# Engagement report – two new parks in North Rosebery

From 5 March to 6 April 2021, we asked the community for feedback on concept plans and naming proposals for two new open spaces in North Rosebery.

**Proposed Allsorts Park, Rosebery - concept design**  
[cityofsydney.nsw.gov.au/consultations](http://cityofsydney.nsw.gov.au/consultations)

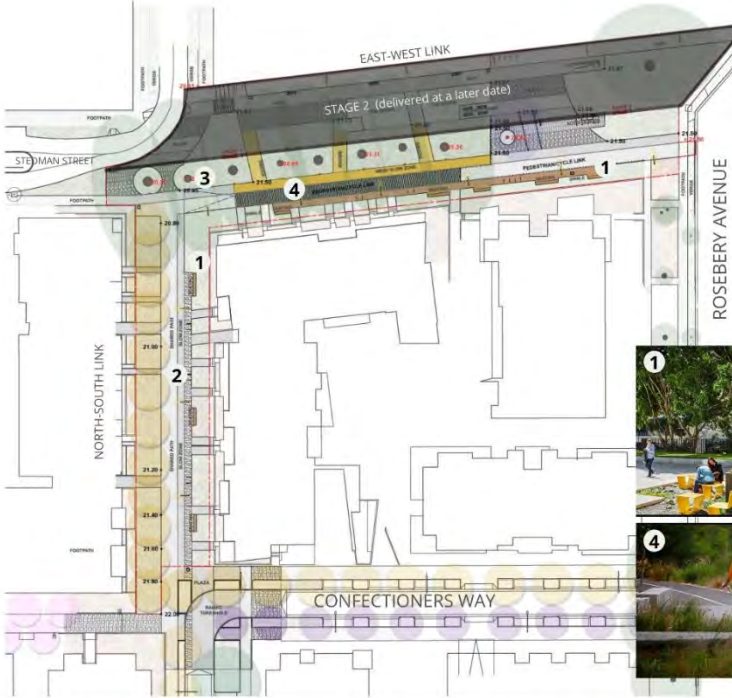
| Amenities   | Total  | City of Sydney Response   |
|---|--|---|
| Concern about skateable elements and noise pollution.                       | Comments: 20<br>Up-votes: 152<br>Down-votes: 3   | Any ‘formal/ designated’ skate park will not be proposed in the developed design.   |

| Concern over multi-purpose court and noise pollution, especially at night.   | Comments: 15<br>Up-votes: 126<br>Down-votes: 24 | Noted. A multi-purpose court will not be part of the developed design   |

| Fenced play areas (especially if the lawn area is off-leash)                                    | Comments: 4<br>Up-votes: 15<br>Down-votes: 5 | Park will be on-leash for dogs.<br><br>Need for fences/ separation to be investigated during design development.                                    |

| Shaded play areas.  | Comments: 3<br>Up-votes: 16                 | Solar access study has been carried out to determine best location for play, turf etc. To be further investigated during design development.  |

**Proposed Honeykiss Park, Rosebery - concept design**  
[cityofsydney.nsw.gov.au/consultations](http://cityofsydney.nsw.gov.au/consultations)

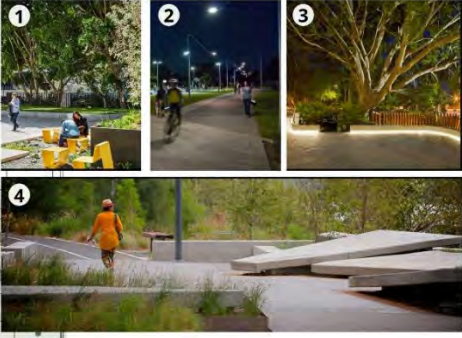
| Support for creative lighting in Honeykiss Park. Request that it doesn't cause light pollution.  | Comments: 1                                     | To be investigated during design development.   |

| Planting  | Total  | City of Sydney Response   |
|---|--|---|
| <b>Seating</b><br>Request to include large benches for people to enjoy the fig trees.<br>Request not to include yellow plastic seating in photo – park benches instead.   | Comments: 2<br>Up-votes: 5<br>Down-votes: 0  | To be investigated during design development.   |
| <b>Footpath</b> to go up both sides of the area all the way to the road, the current path is hidden at the rear with no signage which makes it impossible for law enforcement / delivery drivers to find the addresses of 10-12 / 16 and others on confectioners way, the signage is also poor. Please also remove the ugly eye sore silver fence | Comments: 1<br>Up-votes: 7                   | To be investigated during design development<br><br>Noted regarding fence. This was installed by Meriton and the City will discuss removal with them. |
| <b>Shared zone</b> - prefer to have a separate bike path for safety.  | Comments: 1<br>Up-votes: 3<br>Down-votes: 0  | To be investigated during design development.   |
